Hi-Fi Products  
Service Bulletin

**Model:** CFD-D77

**No.** 68

**Subject:** Mechanical Noise During CD Play

CD Main Board

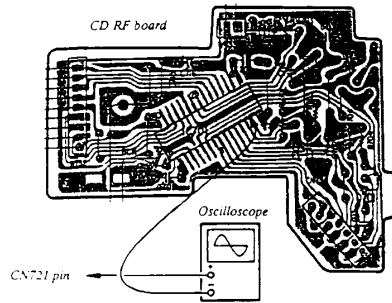
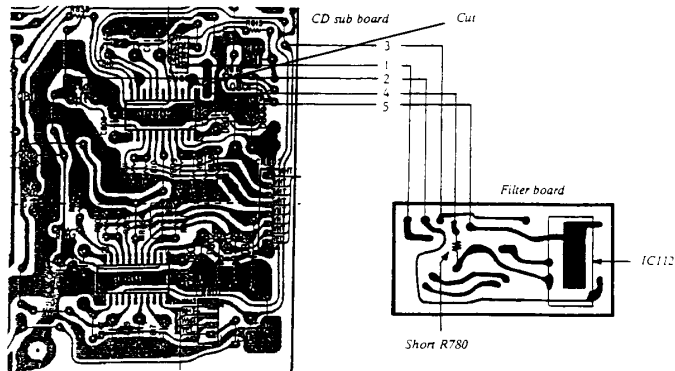
- o Cut the pattern as indicated by the arrow.
- o Perform the focus adjustment as follows.
- o Connect the oscilloscope between Pin 9 of CN721 and Pin 14 of IC701 .
- o Refer to the service manual for further procedure.

CFD-D77  
(CD SUB-BOARD)

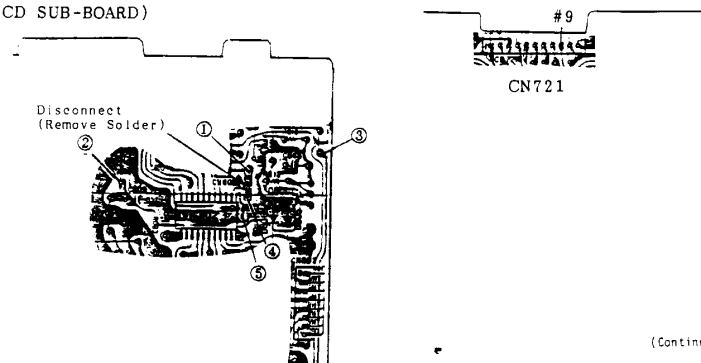
Connect the filter board to the CD sub-board with five wires as indicated by the following table.

Mounted PCB, Filter	1	2	3	4	5
CD Sub-Board	CN803 Pin 3	C809	C801	IC802 Pin 2	IC802 Pin 1
